LOQ-10-20.19
RECONSTRUCTION OF EXISTING SEPARATED
CROSSING WITH N.Y.C. R.R.
LORAIN COUNTY
RIDGEVILLE TOWNSHIP

TITLE SHEET	1
TYPICAL SECTION	2
CALCULATIONS-GENERAL NOTES-TABLES-GENERAL SUMMARY	3
PLAN & PROFILE	4-8
CROSS SECTIONS	9-17
BEFORE ROAD APPROACH & SIDE ROAD CULVERT	18
CULVERT & OUTLET STORM SEWERS	19
STRUCTURES OVER 20' SPAN	20-27
RAILROAD FORCE ACCOUNT WORK	28
CHANGE ORDER N° 2 (ADDED TO PLAN 12-8-52) KT	28-A, B, C.

LOR.-10-20.19
CHANGE ORDER No. 2

STATE OF OHIO DEPARTMENT OF HIGHWAYS BUREAU OF BRIDGES AND RAILROAD CROSSINGS					
GIRDER DETAILS BRIDGE NO. 10-204 OVER NEW YORK CENTRAL R.R.					
LORAIN COUNTY SEC. LOR-10-20.19 Sta 1080+60.50					
DESIGNED	DRAWN	TRACED	CHECKED	REVIEWED	DATE
C.R.	C.R.	W.J.R.	W.C.K.	B.F.G.	12-31-51

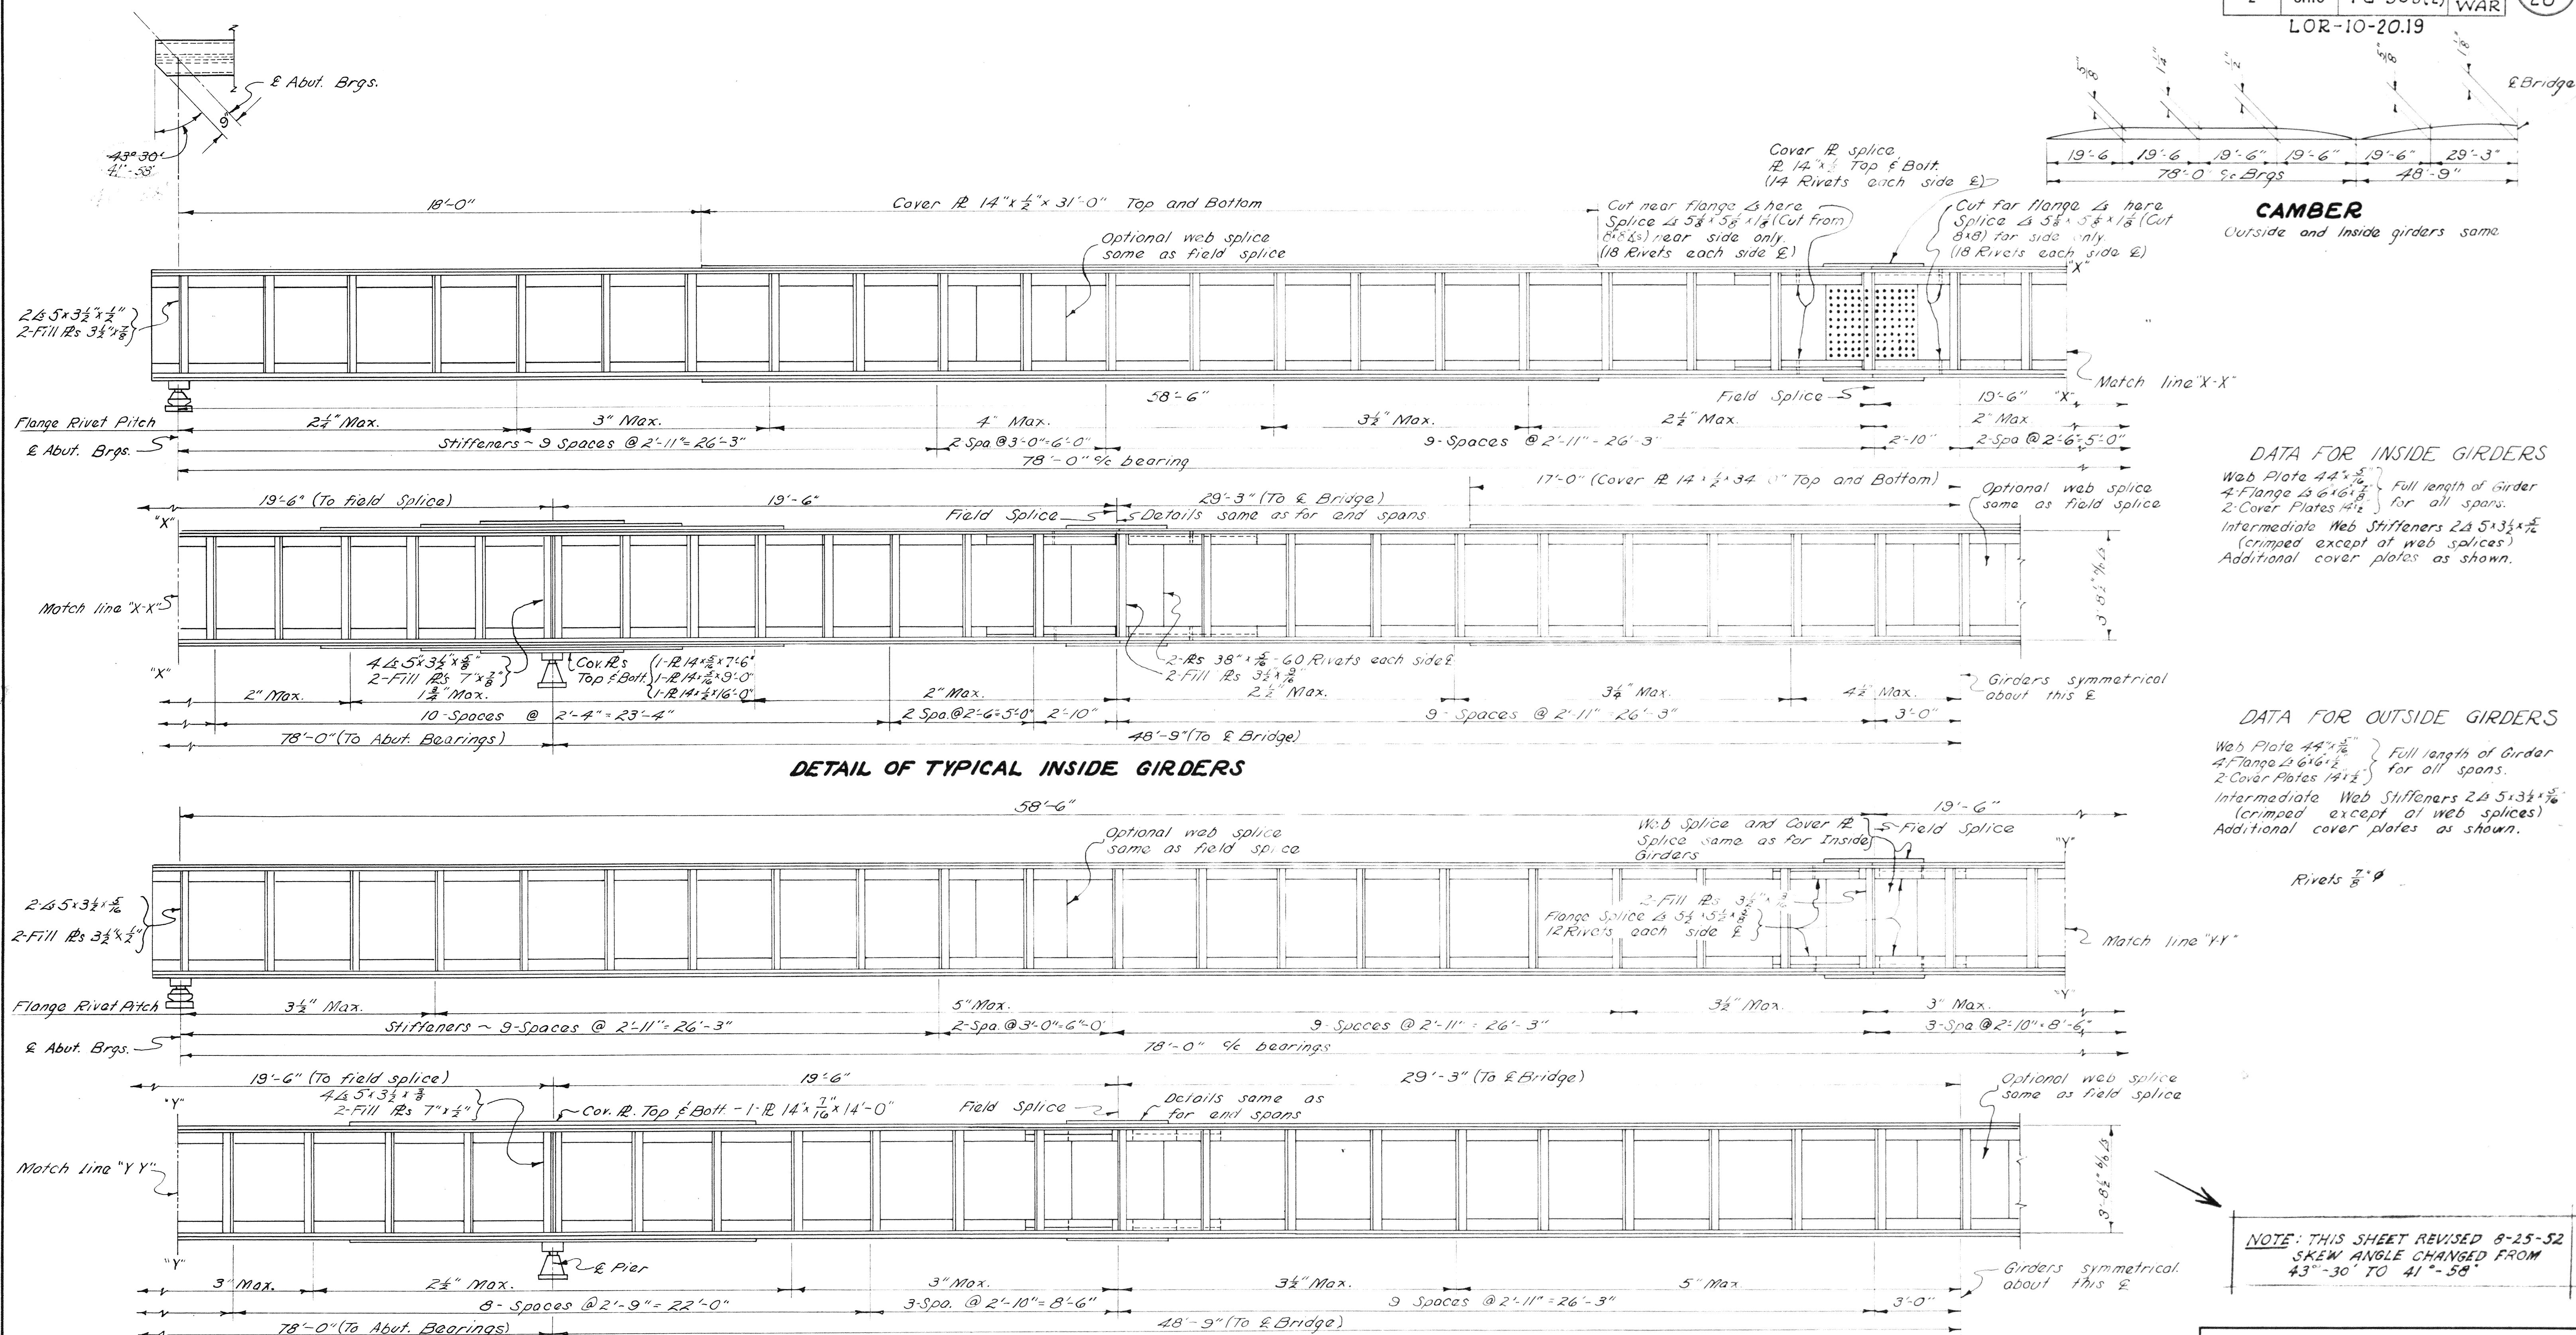
NOTE: THIS SHEET REVISED 8-25-52
 SKEW ANGLE CHANGED FROM
 43°-30' TO 41°-58'

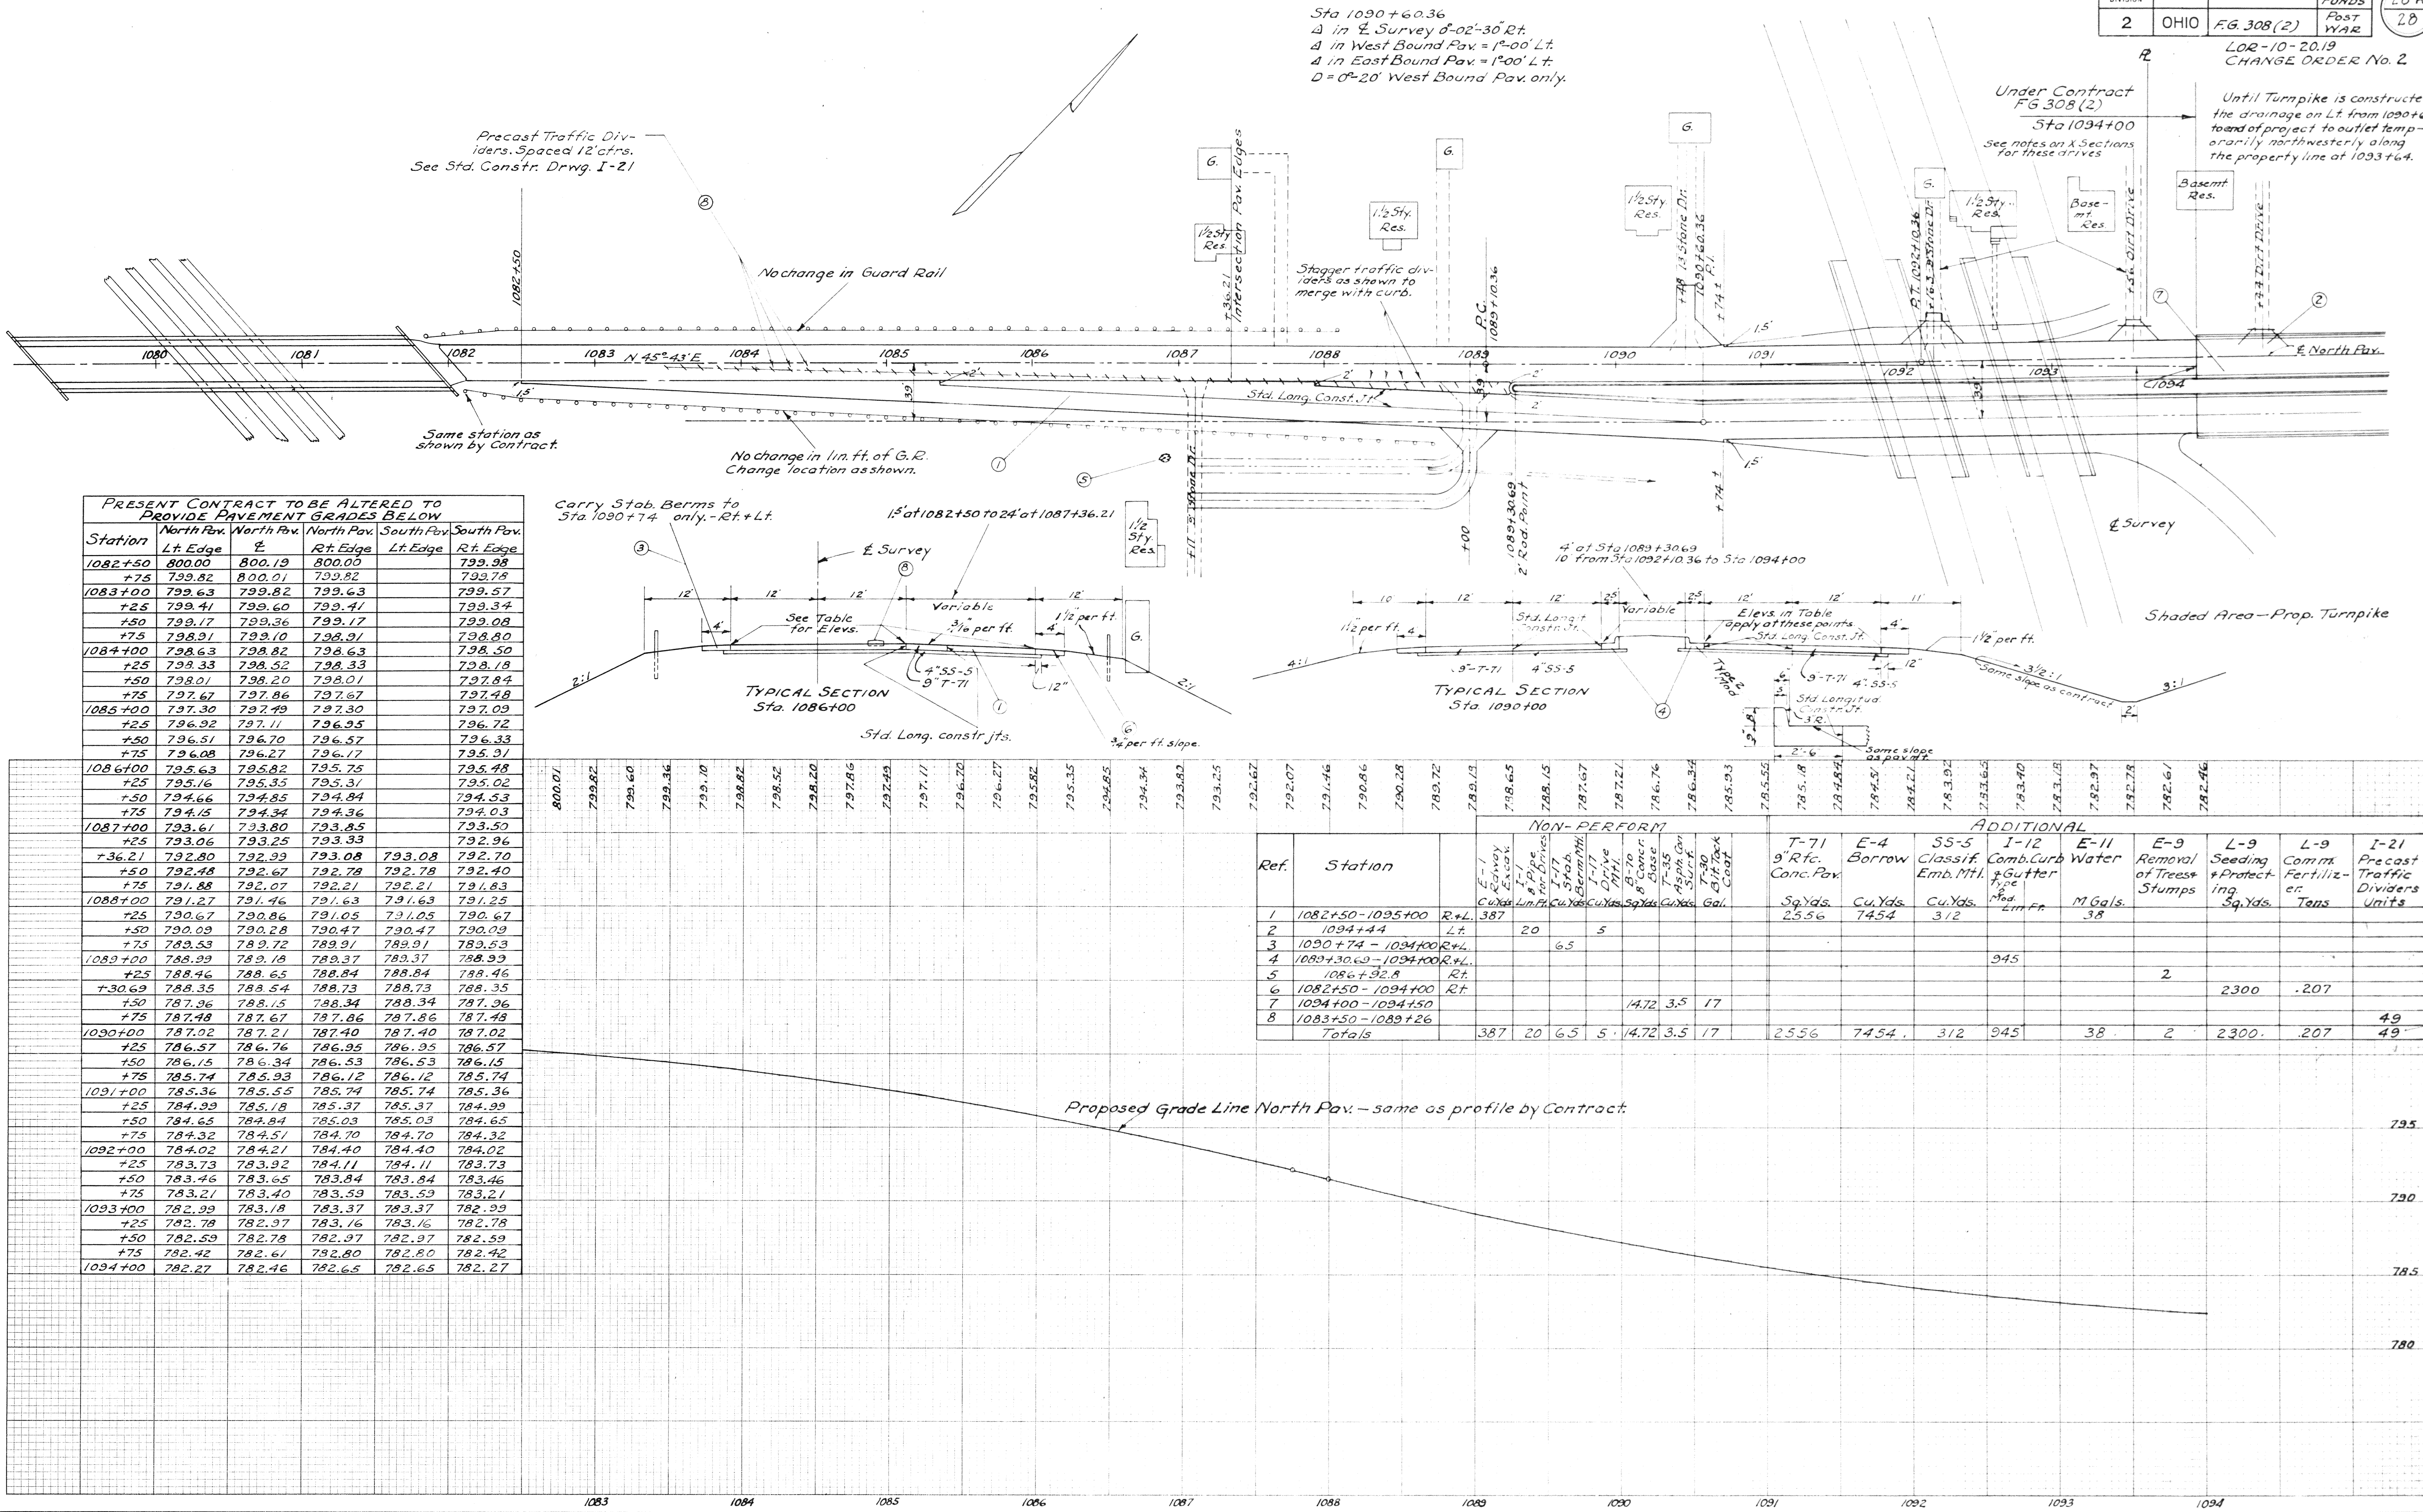
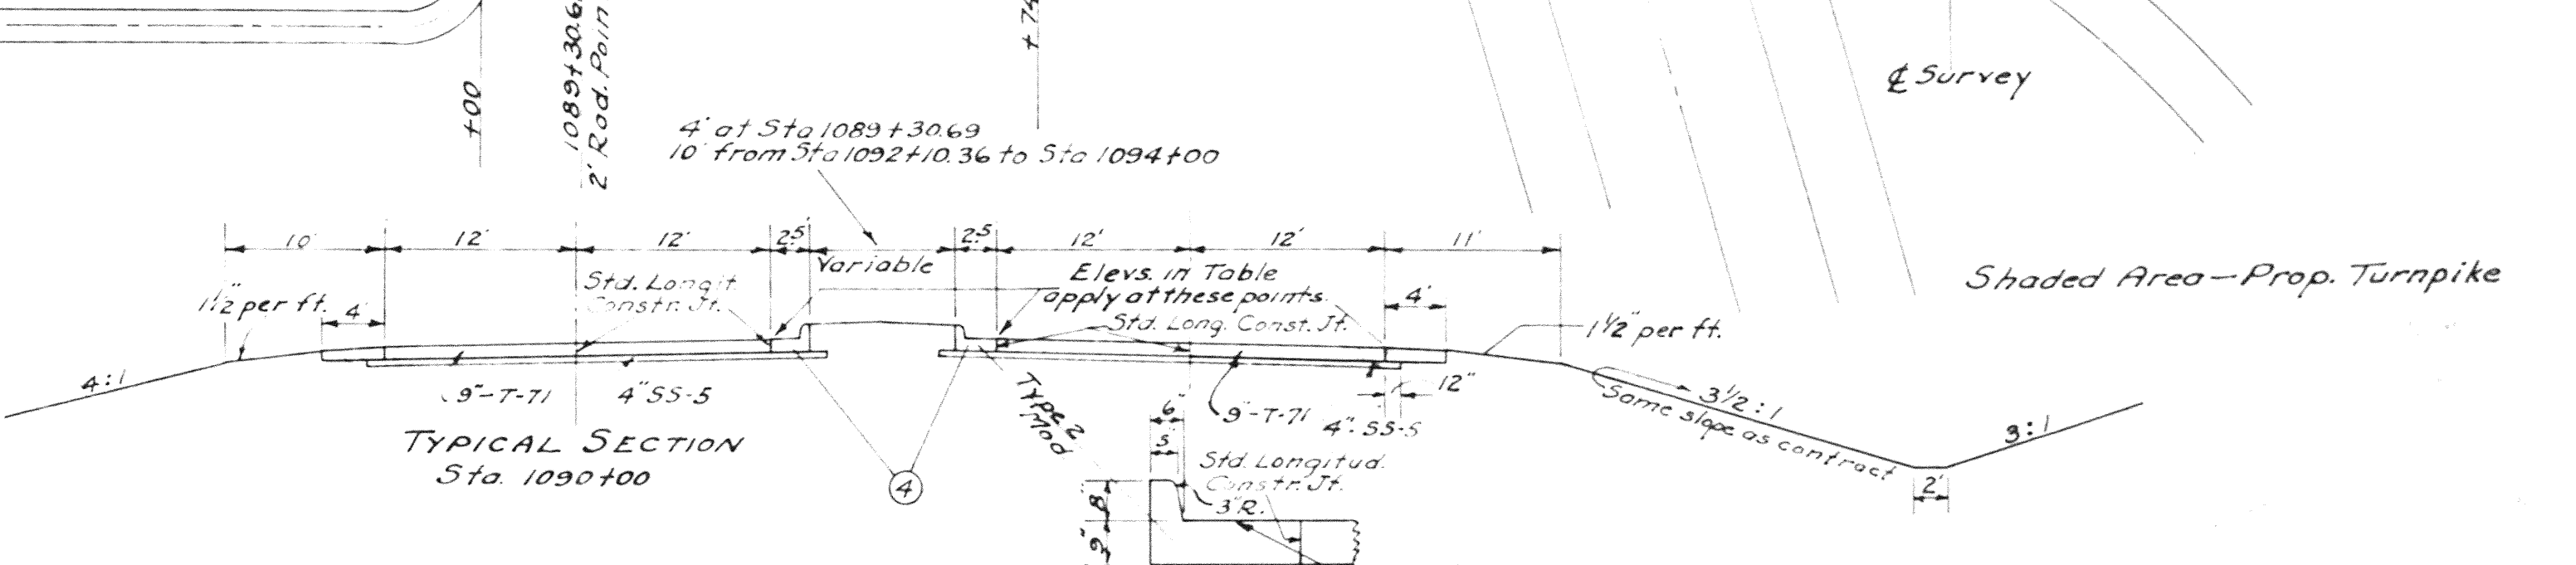
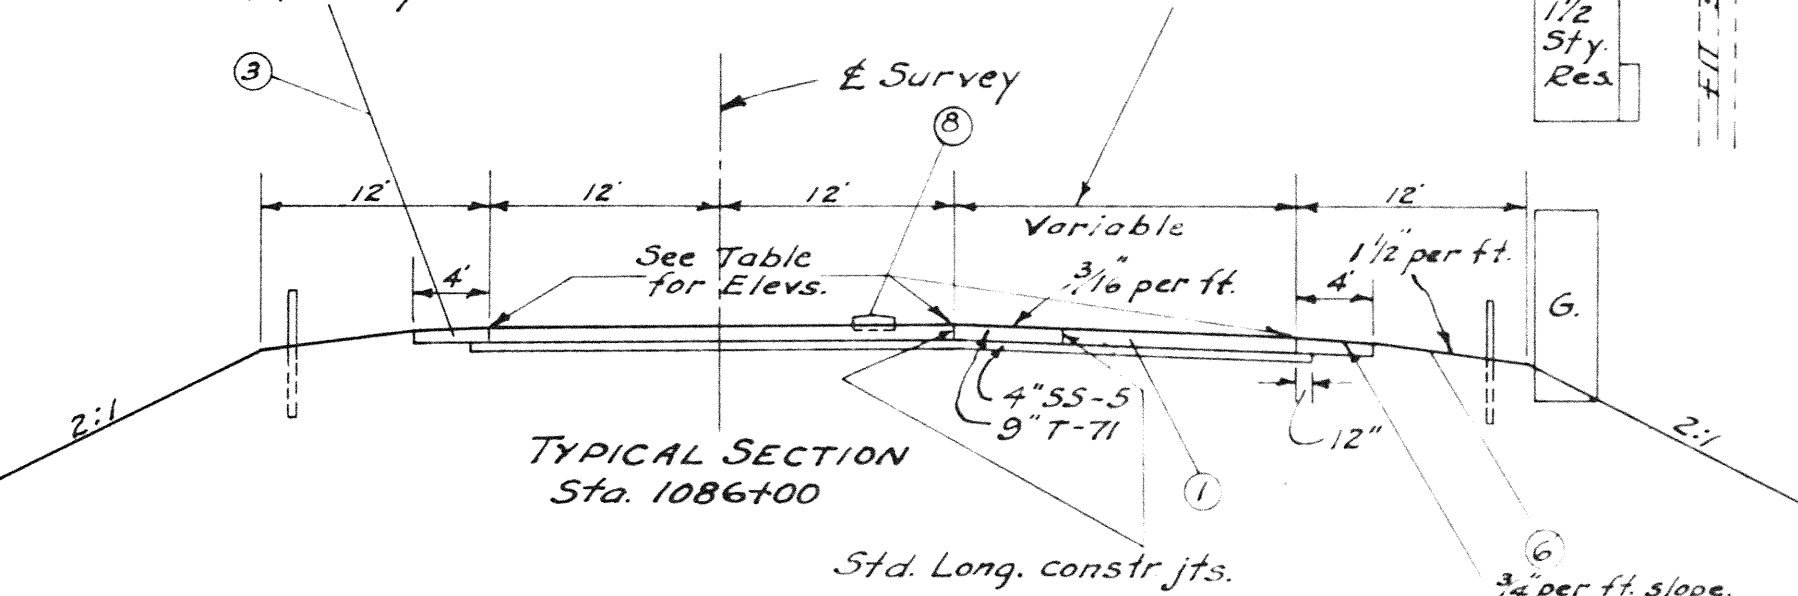
PRESENT CONTRACT TO BE ALTERED TO PROVIDE PAVEMENT GRADES BELOW

Carry Stab. Berms to Sta. 1090+74 only - Rt. + Lt.

Proposed Grade Line North Pav. - same as profile by Contract

Station	North Pav. Lt. Edge	North Pav. C.	North Pav. Rt. Edge	South Pav. Lt. Edge	South Pav. Rt. Edge
1082+50	800.00	800.19	800.00	799.98	799.98
+75	799.82	800.01	799.82	799.78	799.78
1083+00	799.63	799.82	799.63	799.57	799.57
+25	799.41	799.60	799.41	799.34	799.34
+50	799.17	799.36	799.17	799.08	799.08
+75	798.91	799.10	798.91	798.80	798.80
1084+00	798.63	798.82	798.63	798.50	798.50
+25	798.33	798.52	798.33	798.18	798.18
+50	798.01	798.20	798.01	797.84	797.84
+75	797.67	797.86	797.67	797.48	797.48
1085+00	797.30	797.49	797.30	797.09	797.09
+25	796.92	797.11	796.92	796.72	796.72
+50	796.51	796.70	796.51	796.33	796.33
+75	796.08	796.27	796.08	795.91	795.91
1086+00	795.63	795.82	795.63	795.48	795.48
+25	795.16	795.35	795.16	795.02	795.02
+50	794.66	794.85	794.66	794.53	794.53
+75	794.15	794.34	794.15	794.03	794.03
1087+00	793.61	793.80	793.61	793.50	793.50
+25	793.06	793.25	793.06	792.96	792.96
+36.21	792.80	792.99	792.80	792.70	792.70

+50	792.48	792.67	792.48	792.40	792.40
+75	791.88	792.07	791.88	791.83	791.83
1088+00	791.27	791.46	791.27	791.25	791.25
+25	790.67	790.86	790.67	790.67	790.67
+50	790.09	790.28	790.09	790.09	790.09
+75	789.53	789.72	789.53	789.53	789.53
1089+00	788.99	789.18	788.99	788.99	788.99
+25	788.46	788.65	788.46	788.46	788.46
+30.69	788.35	788.54	788.35	788.35	788.35
+50	787.96	788.15	787.96	787.96	787.96
+75	787.48	787.67	787.48	787.48	787.48
1090+00	787.02	787.21	787.02	787.02	787.02
+25	786.57	786.76	786.57	786.57	786.57
+50	786.15	786.34	786.15	786.15	786.15
+75	785.74	785.93	785.74	785.74	785.74
1091+00	785.36	785.55	785.36	785.36	785.36
+25	784.99	785.18	784.99	784.99	784.99
+50	784.63	784.84	784.63	784.63	784.63
+75	784.32	784.51	784.32	784.32	784.32
1092+00	784.02	784.21	784.02	784.02	784.02
+25	783.73	783.92	783.73	783.73	783.73
+50	783.46	783.65	783.46	783.46	783.46
+75	783.21	783.40	783.21	783.21	783.21
1093+00	782.99	783.18	782.99	782.99	782.99

+25	782.78	782.97	782.78	782.78	782.78
+50	782.59	782.78	782.59	782.59	782.59
+75	782.42	782.61	782.42	782.42	782.42
1094+00	782.27	782.46	782.27	782.27	782.27
